RSN: 1902240 | PERMIT# 25-2534172 -LT (PLAN REVISION TO PERMIT# 25-2513934 -CM, RSN:1881854)

PLAN REVISION TO PERMIT# 25-2513934 -CM, RSN:1881854

City of Aurora Building Division
Reviewed for Code Compliance
Approved as Noted: Robert Lowman
Date: Jun 06, 2025
2021 INTERNATIONAL CODES & 2023 NEC

JOB 24464.0000
DATE 05.30.25
SHEET E06-03

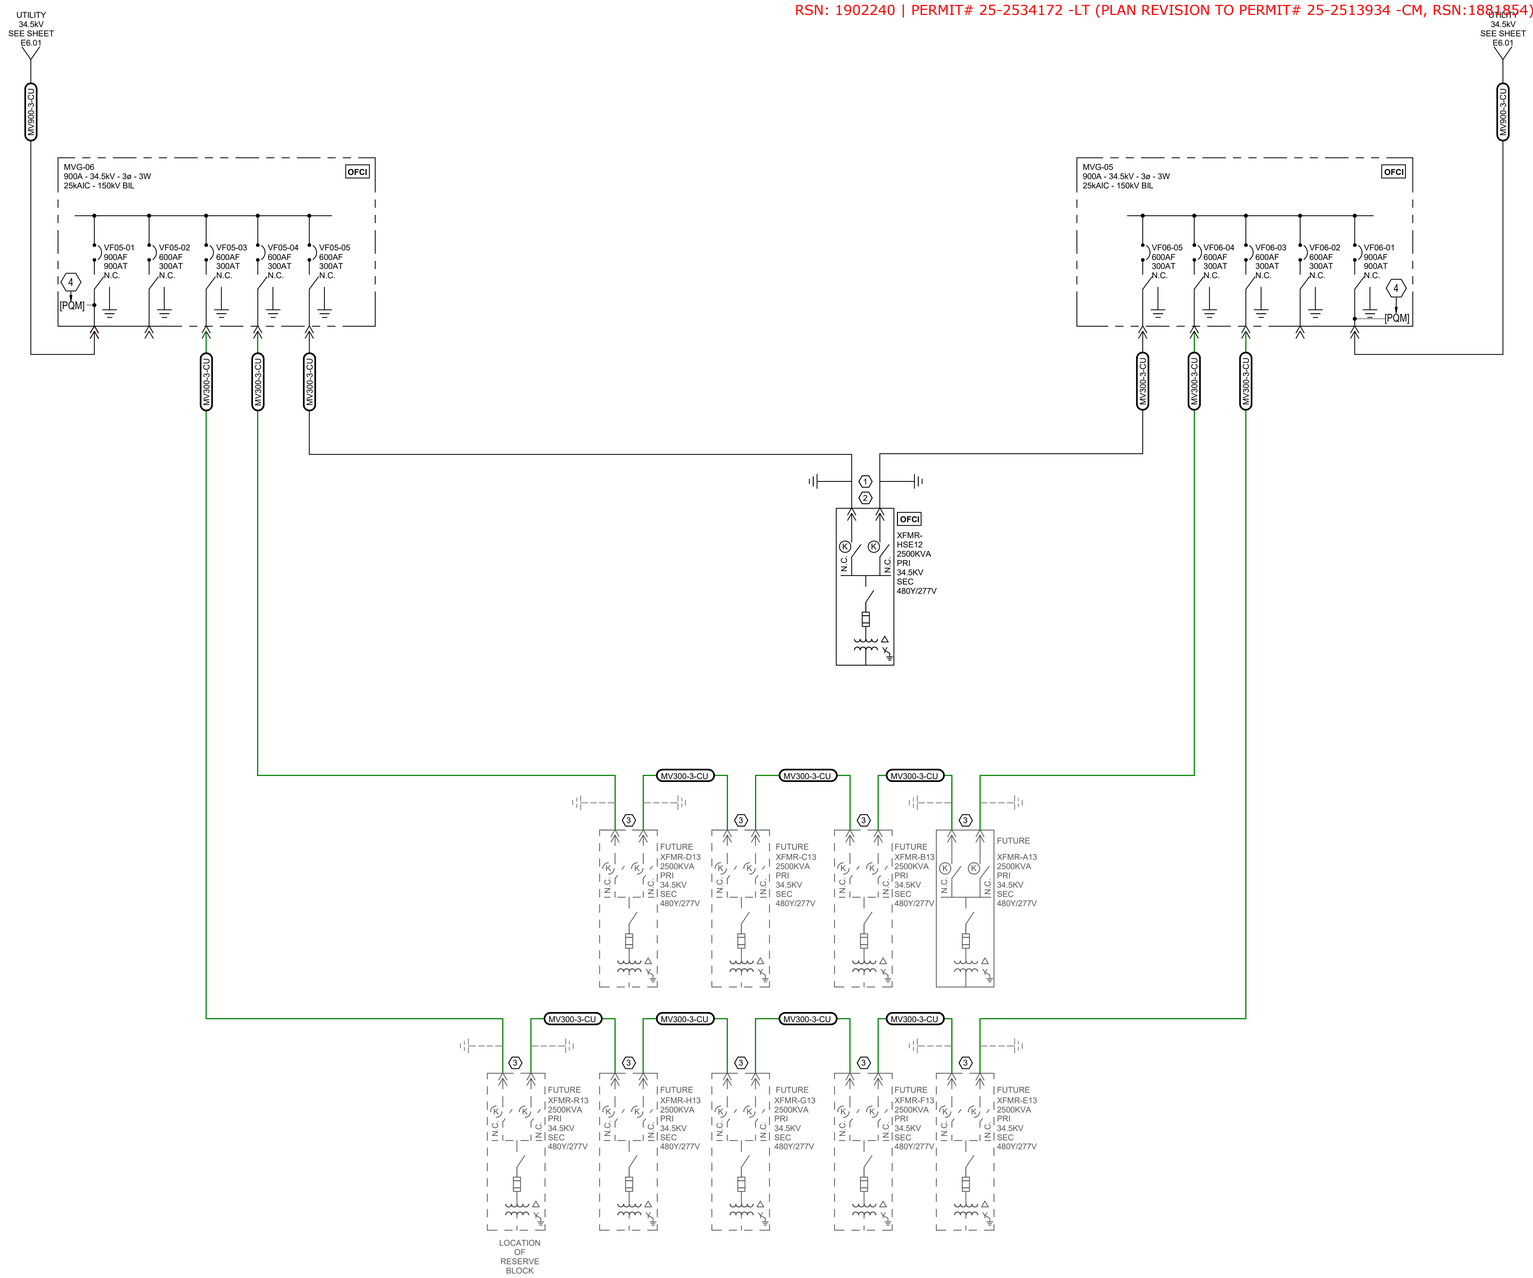
Sheet Number: E06-01, E06-02, E06-03, E06-04, E06-05
a. Update: Added sheet note D clarifying pad requirements. Clarified where conduit
and wire vs. Conduit only is to be installed.

E06-04

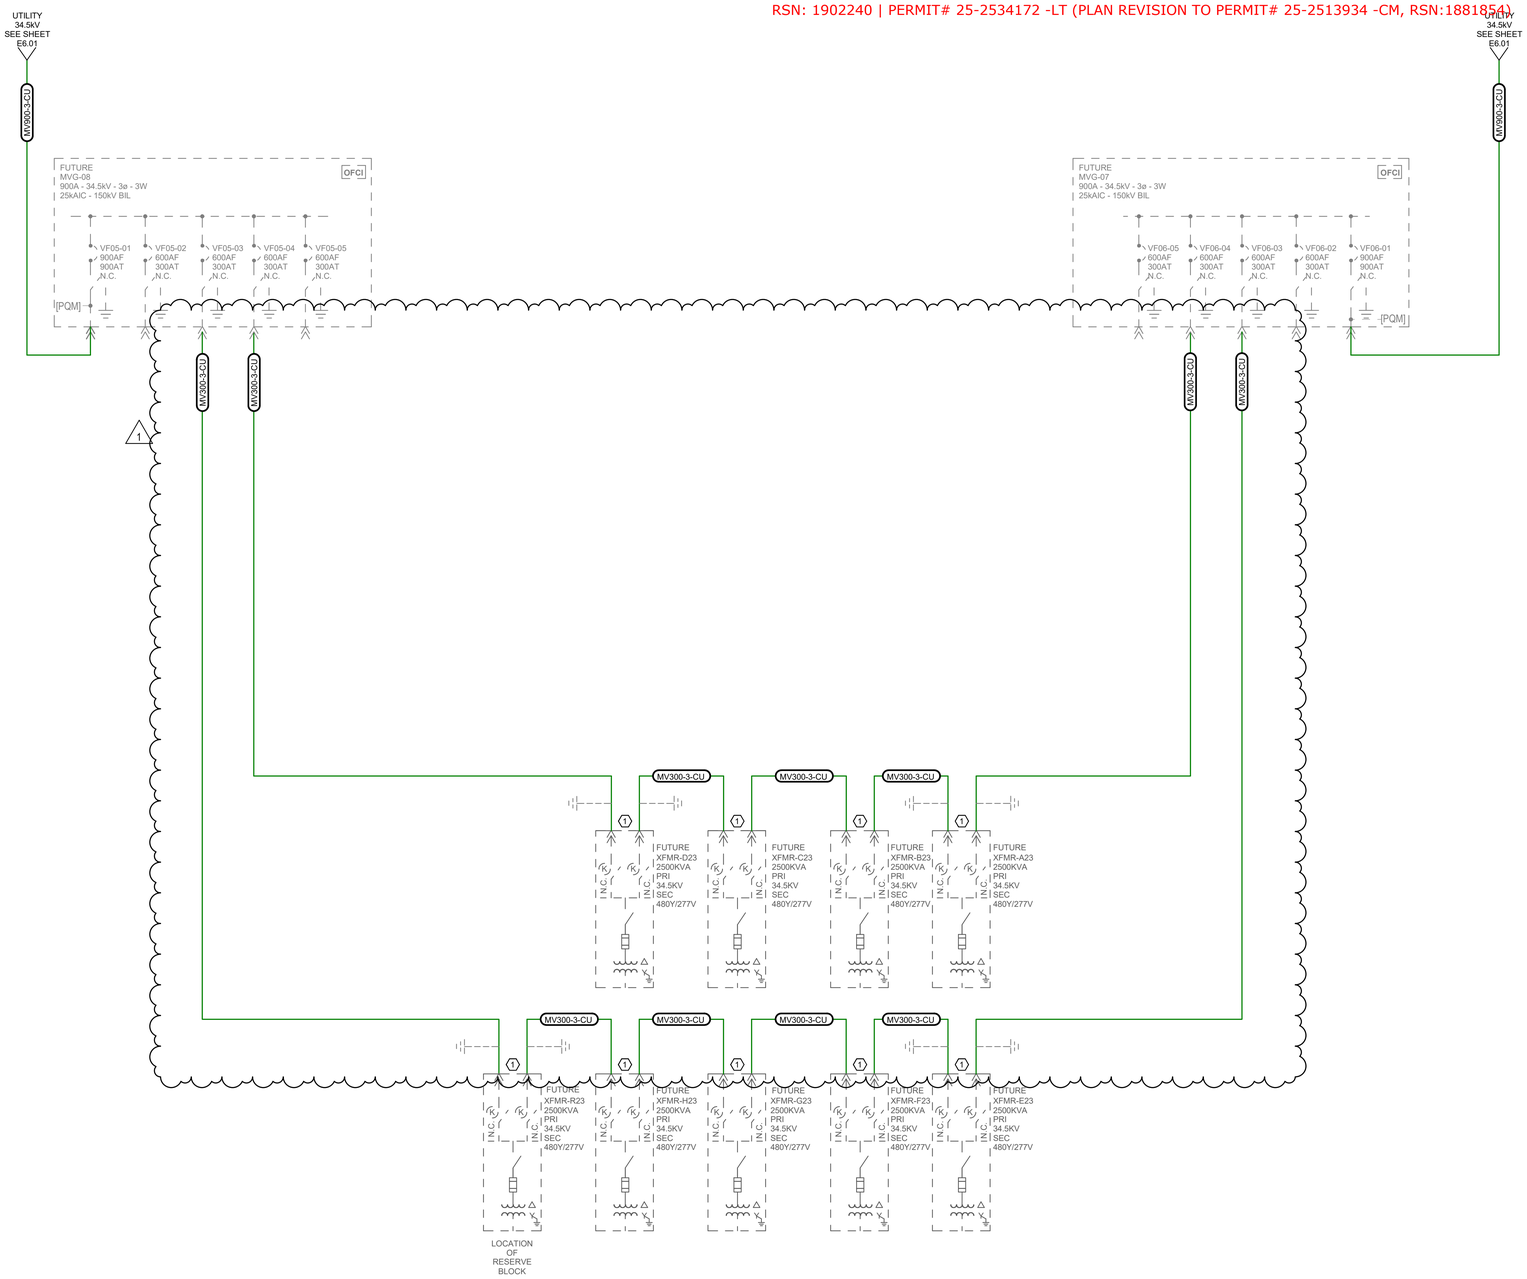
Sheet Number: E06-01, E06-02, E06-03, E06-04, E06-05
a. Update: Added sheet note D clarifying pad requirements. Clarified where conduit and wire vs. Conduit only is to be installed.

JOB 24464.0000
DATE 05.30.25
SHEET E07-10

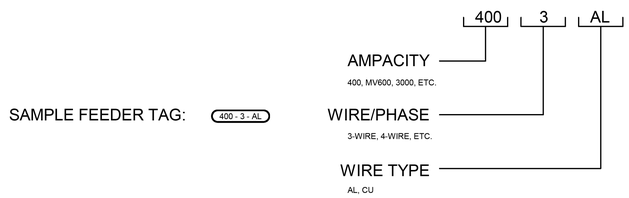
Sheet Number: E07-10
a. Update: Added Transformer Schedule, minor revisions on the feeder schedule to capture any new feeder types.
